Paul Carpenter, Senior Engineering Geologist
 Department of Toxic Substances Control (DTSC) 8800 Cal Center Drive, Sacramento, CA 95826

ACME (Aerospace Contamination Museum of Education) Comments - Draft NASA Field Sampling Plan Subgroup 5

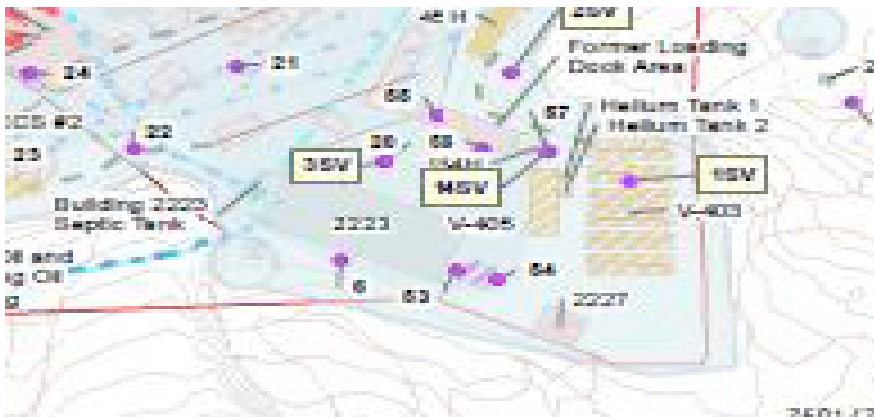
Regarding the Santa Susana Field Laboratory's (SSFL) Draft Field Sampling Plan (FSP) Subgroup 5 for the National Aeronautics and Space Administration (NASA) controlled portion of the SSFL we need to keep in mind that the drainage from these areas create the headwaters to the Los Angeles River (R-2 Pond above photo) and with the City of Los Angeles' planned revitalization, the most protective cleanup should be administered as per the Administrative Order on Consent signed by NASA in December, 2010.

In Section 1.15 Group9, R-2 Ponds (Above Photo) - Proposed Sampling needs to include more sampling where it meets Delta and PLF.

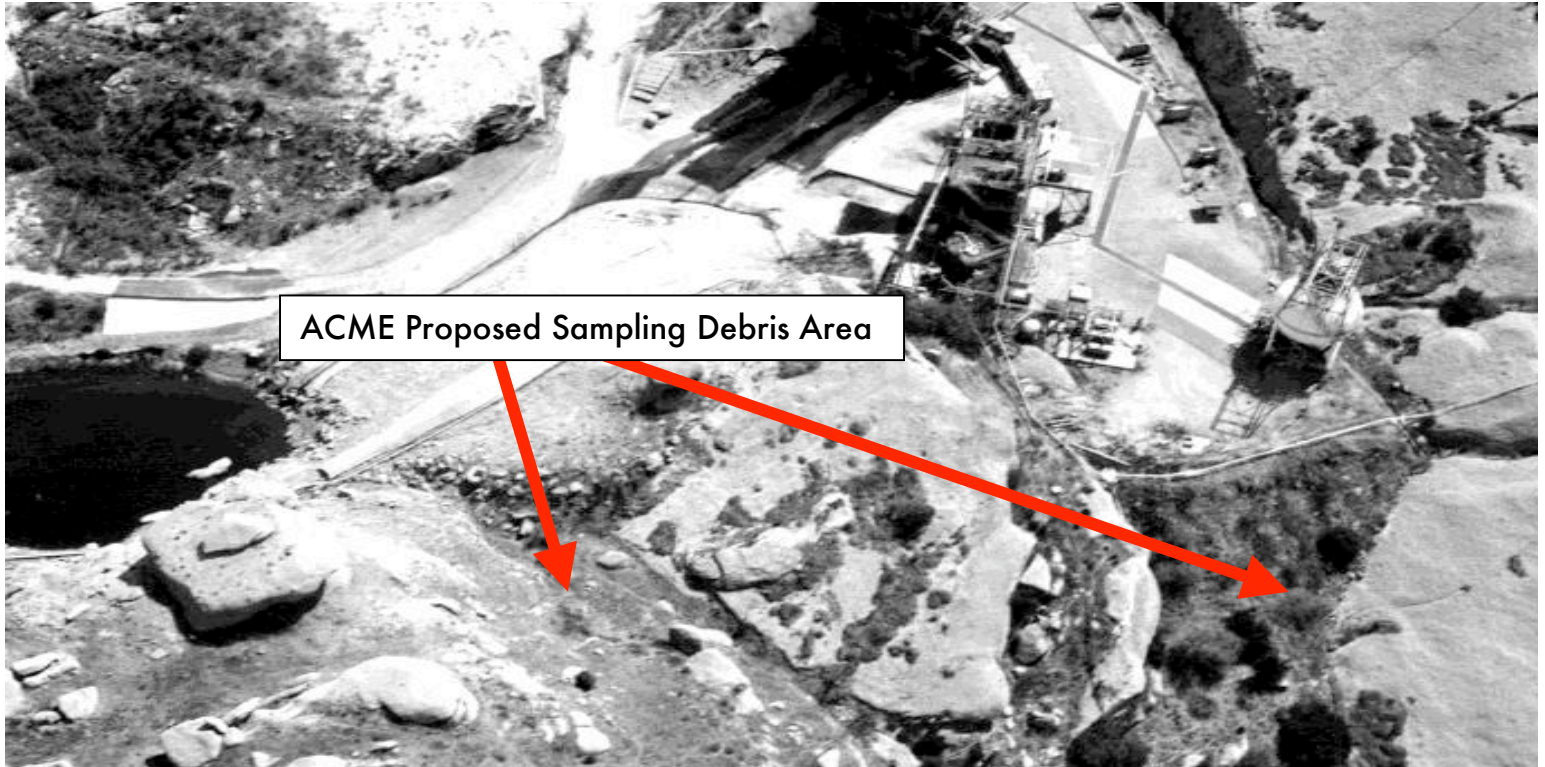
In Section 1.14 Delta Test Area - More sampling needs to be done behind building 2227 as it was a drum storage area
 (Left Photo)

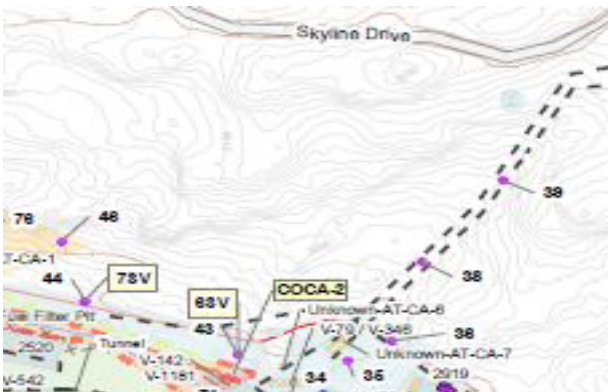
In Section 1.14 Delta 4, 5 and 6 debris areas understanding that this area was used by the Chumash and other native tribes, sampling can still be conducted with the oversight of tribal appointees as was done in the Environmental Protection Agency's study in AREA IV of the SSFL, inset photo below. These are known dumping sites and form tributaries to the Los Angeles River headwaters.

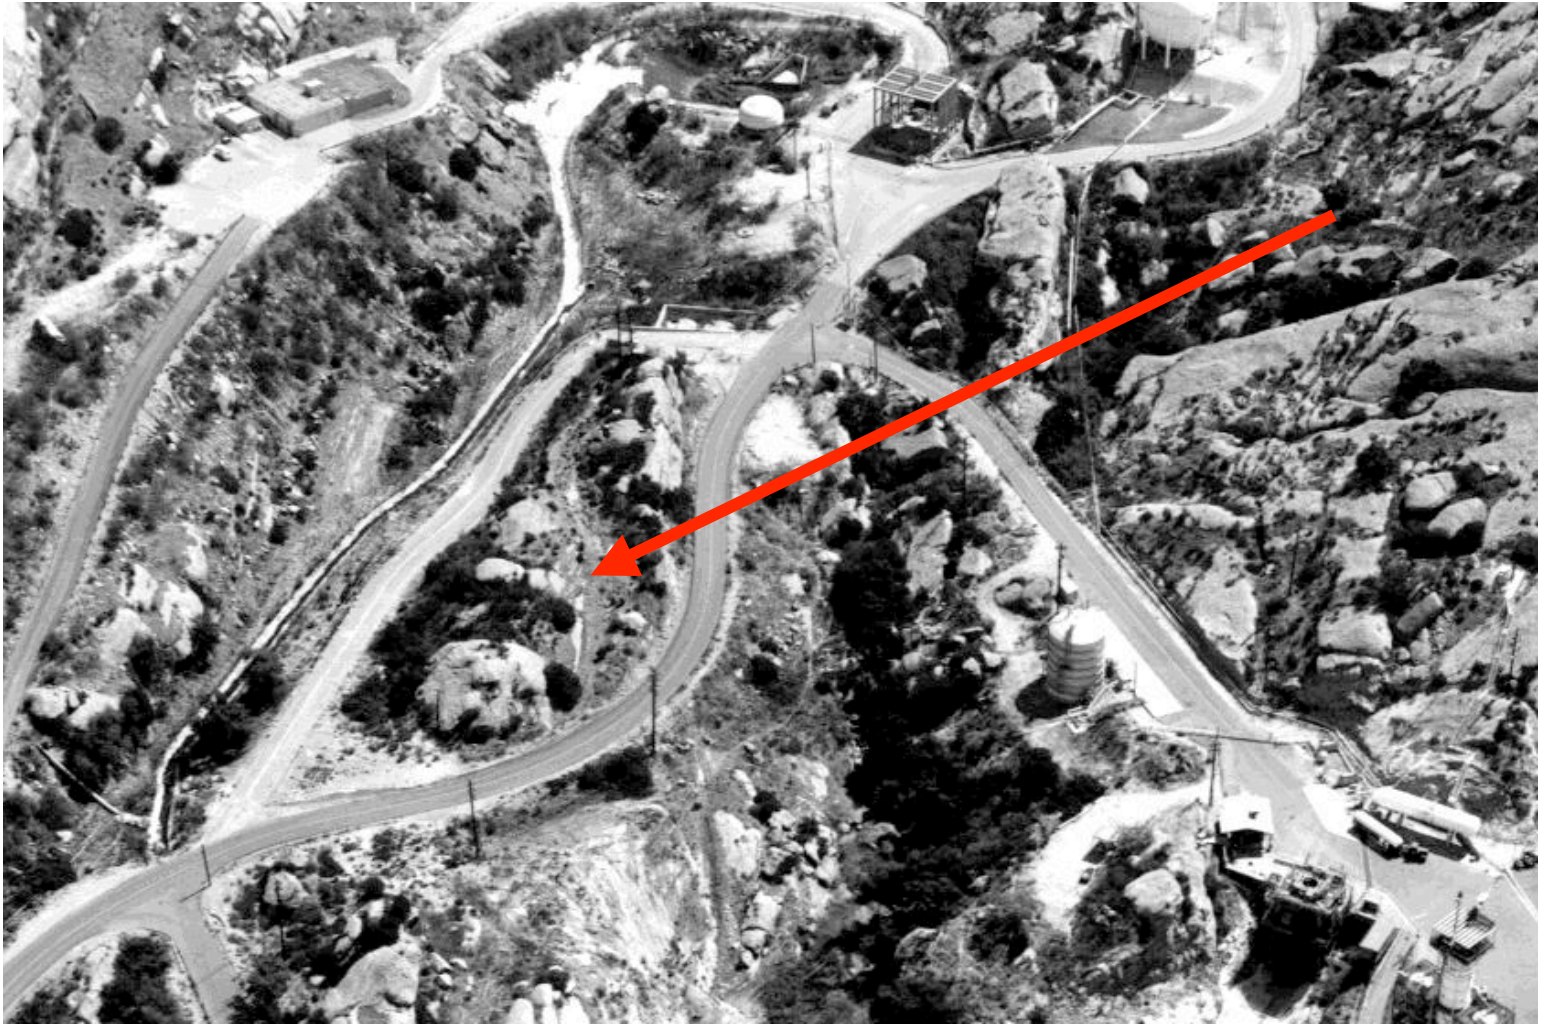
The below photo points to an area we can call "The Island" for now, currently no proposed sampling in this island, please change that. There is a drainage pathway, and needs to be included in the FSP.

More sampling needs to be done within the pathway up to Skyline Drive (see photo to left). This is a pathway for TCE tainted water to leak out and contaminates the soils around. In closing depth sampling needs to be conducted under the COCA test stands to understand the extent of the contamination in the unique situation where stands where built upon stands.
